UNITED STATES PATENT AND TRADEMARK OFFICE

APPLICATION NO.	FILING DATE	FIRST NAMED INVENTOR	ATTORNEY DOCKET NO.	CONFIRMATION NO.
10/511,911	08/18/2005	Ib Joergensen	31698-2030	4306

Office Action Summary	Application No.	Applicant(s)	
	10/511,911	JOERGENSEN ET AL.	
	Examiner	Art Unit	
	LoAn H. Thanh	3763

DETAILED ACTION

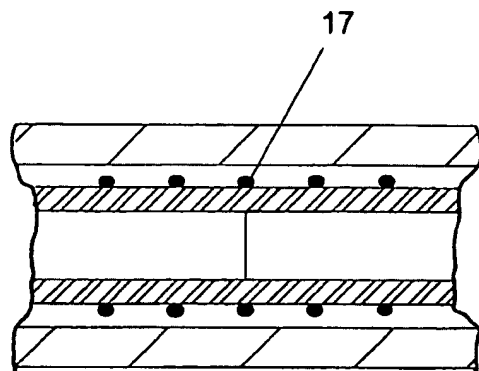
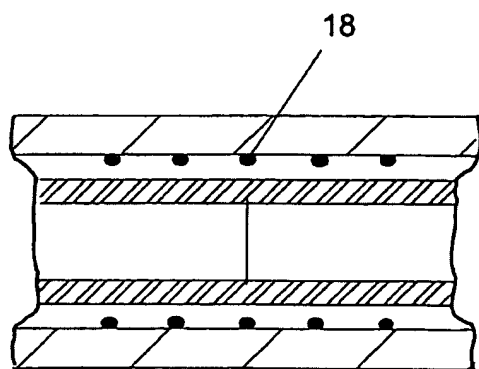
The new drawing has been approved. However, the drawing objection with respect to the coating is still maintained.

approved
9/5/16
